# CRMC DECISION WORKSHEET

**2020-09-059**

DATE: 12 February 2022, revised 10 March 2022  
TO: Jeffrey M. Willis, Executive Director  
FROM: T. Silvia, Permit Staff  
SUBJECT: CRMC File No. 2020-09-059

Applicant's Name: William & Suzanne Healy  
Project: Construct and maintain a new residential boating facility consisting of a ~ 4' x 80' fixed timber pier, 3' x 14' ramp and 8' x 18.75' (150sf) terminal float extending ~69' seaward of the cited MLW mark.  
Location: 147 Conanicus Road, Narragansett, plat N-E, lot 35  
Water Type/Name: Type 2, Low Intensity Use,  
Coastal Feature: Coastal wetland complex backed by coastal bank  
Recommendation: No technical objection, defer to the Council for consideration of Objector comments  
Reviewed Plans: *"Proposed Residential Dock, 147 Conanicus Road, Narr.."* twelve sheets dated April 2020 with sheet 8 revised 12/31/20 and sheets 3-6 **last revised 9/10/21** by Russel J. Morgan, RPE **and** *"Boundary Survey, 147 Conanicus Avenue, Narragansett, Mr. William Healy.."* **last revised 9/1/21** by Robert G. Babcock, PLS.

# Figure 1: Healy

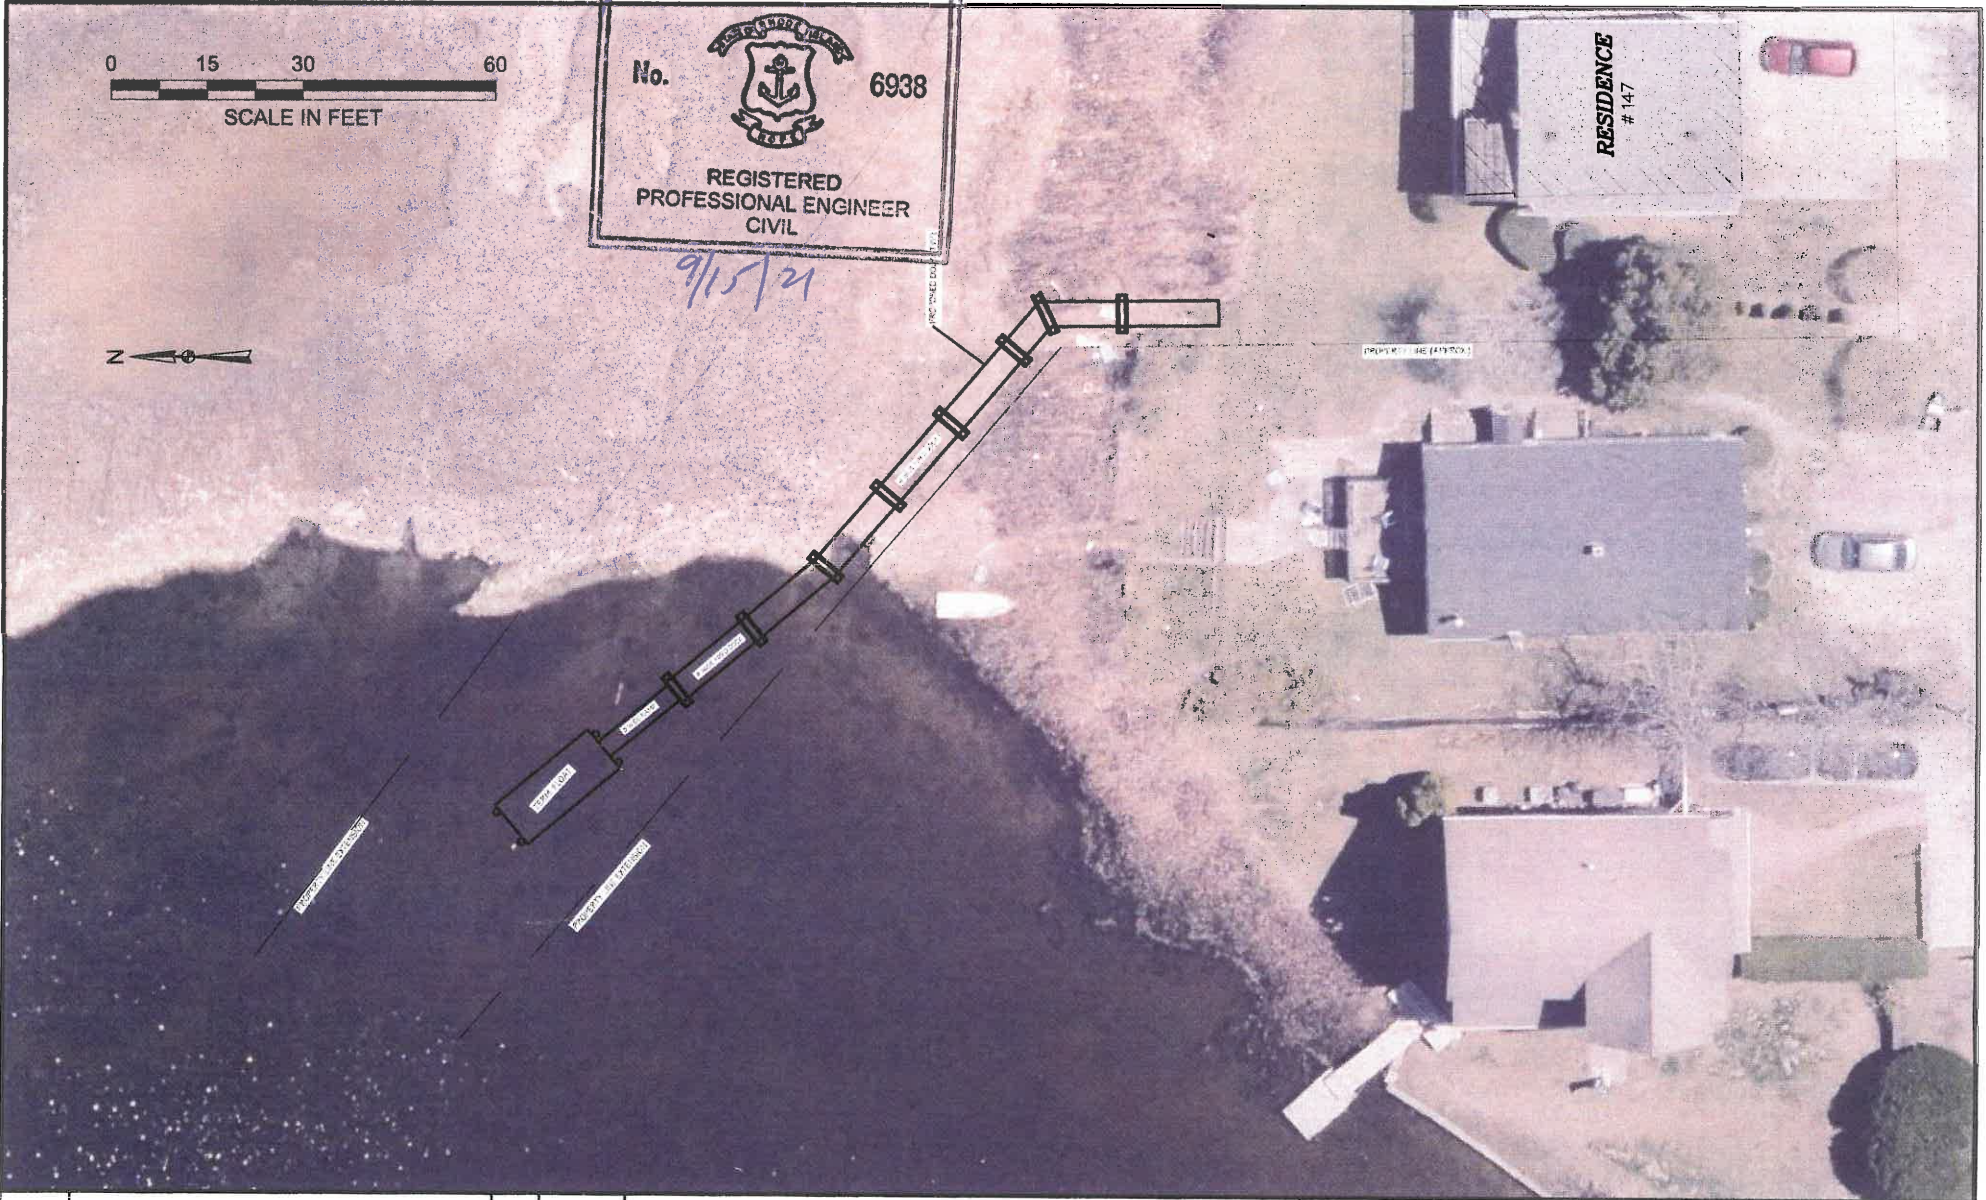
1. The parcel is located along the eastern shore of the central portion of the Narrow River at the southwest corner of a large coastal wetland complex (Figure 1). Densely developed residential neighborhoods with numerous residential boating facilities are common along both sides of this stretch of the River. On this east-west street, an existing dock is located further west, however no docks are currently permitted to the east or on the abutting western parcel. The coastal feature is coastal wetland (predominantly salt marsh) backed by coastal bank. Tidal channels and pools exist within the marsh complex, with a mixed wetland/upland *Phragmites* sp. perimeter.

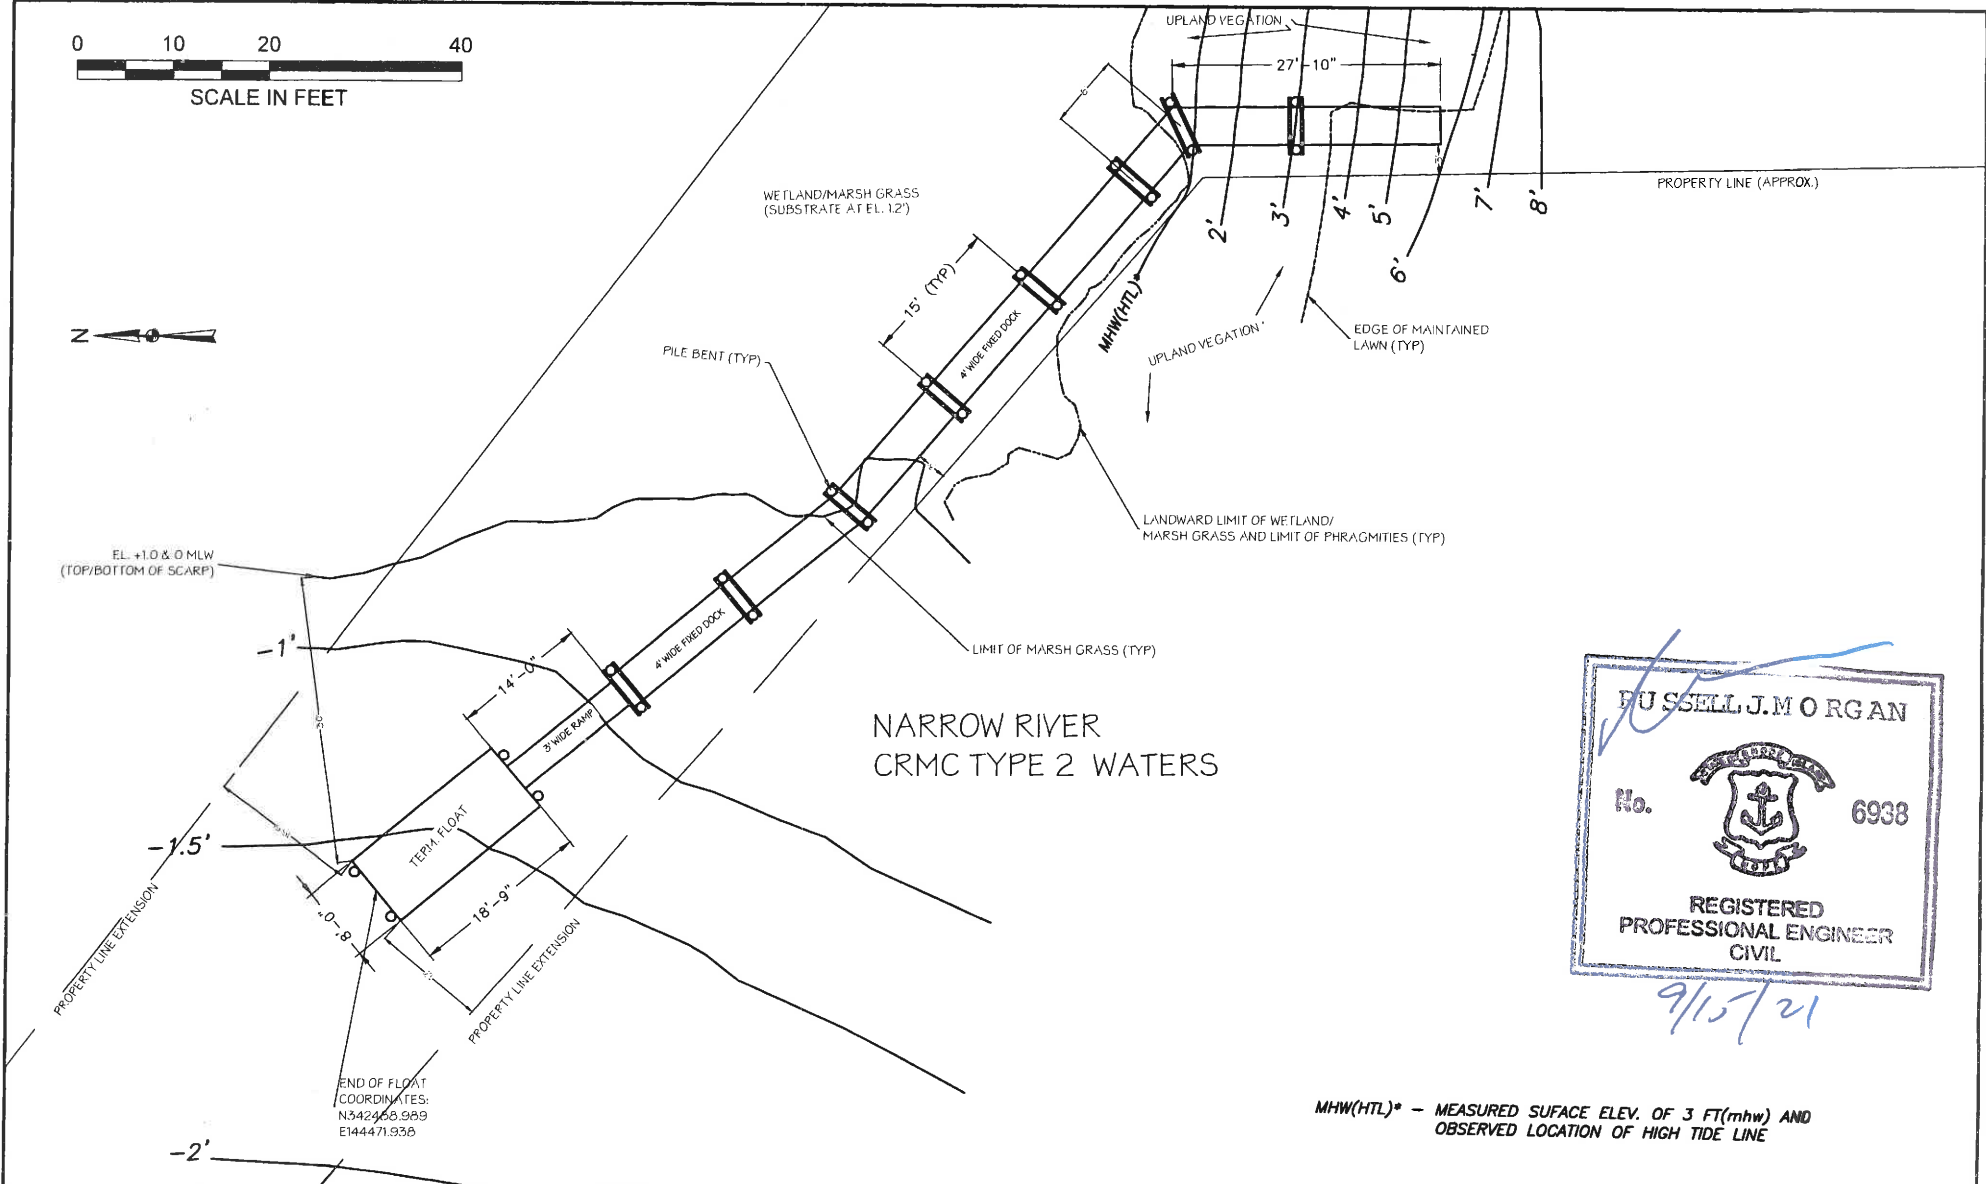
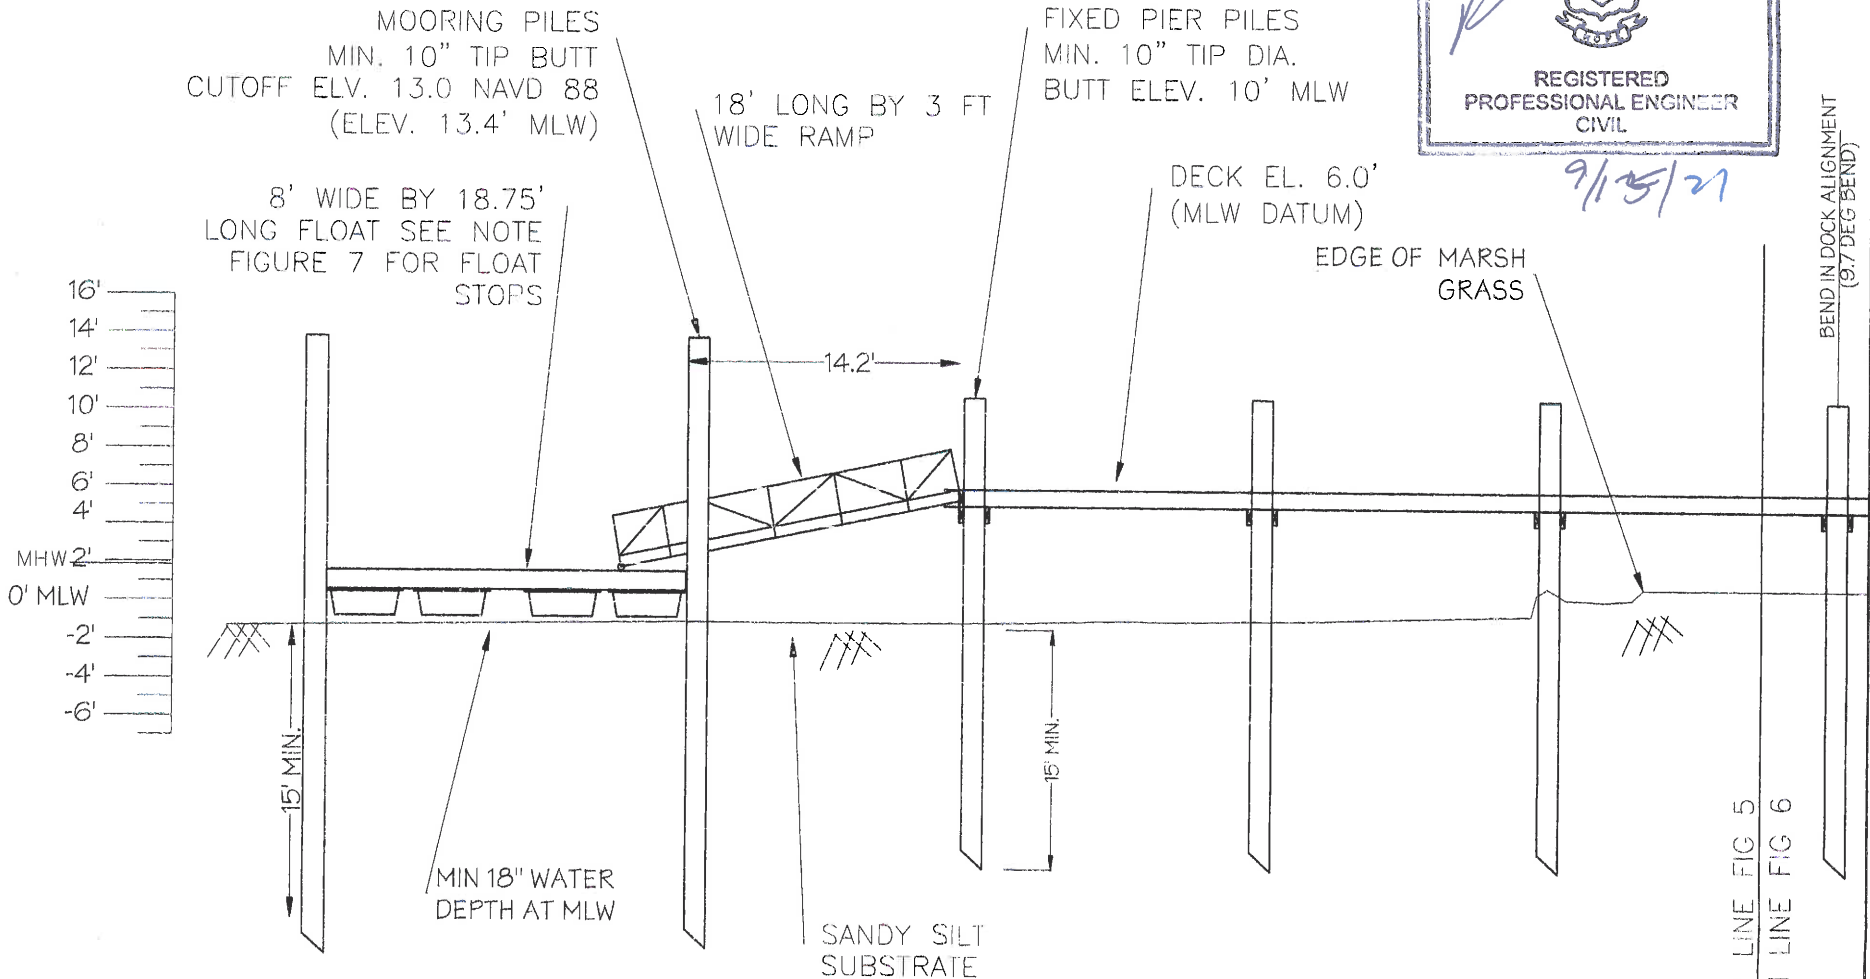
In response to your email to me regarding feedback to the submitted assent I developed the following letter response and revised Figures 3, 4,5 and 6 to reflect the requested changes. Additionally, a revised site survey plan is attached developed by Diprete Engineering indicating the revised dock location.

As requested, the proposed dock location has been moved towards the southern property line. Additionally, we delineated the limit of the marsh and Phragmites and located the High Tide Line. The revised layout is reflected on the attached Figures 3 and 4. We have tried in the past to have the southern abutter provide the Healy's with a letter of no objection and they have refused, so although requested we cannot provide this. A letter of no objection has been obtained from the eastern abutter (Felice Orton) and is attached. We have also attached a site survey drawing that has been revised to reflect the new dock location.

FIXED DOCK FRAMING PLAN AND DETAILS

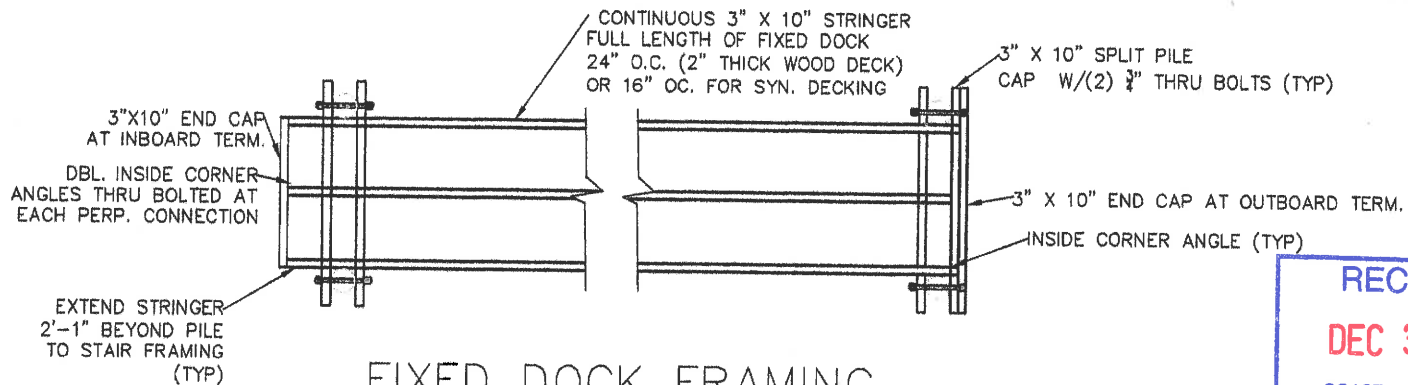
This resubmittal includes the original submission materials with the addition of the a site survey and proposed dock location plan completed by Diprete Engineering and dated December 18, 2020 and a revised Figure 8 "Fixed Dock Framing and Details".
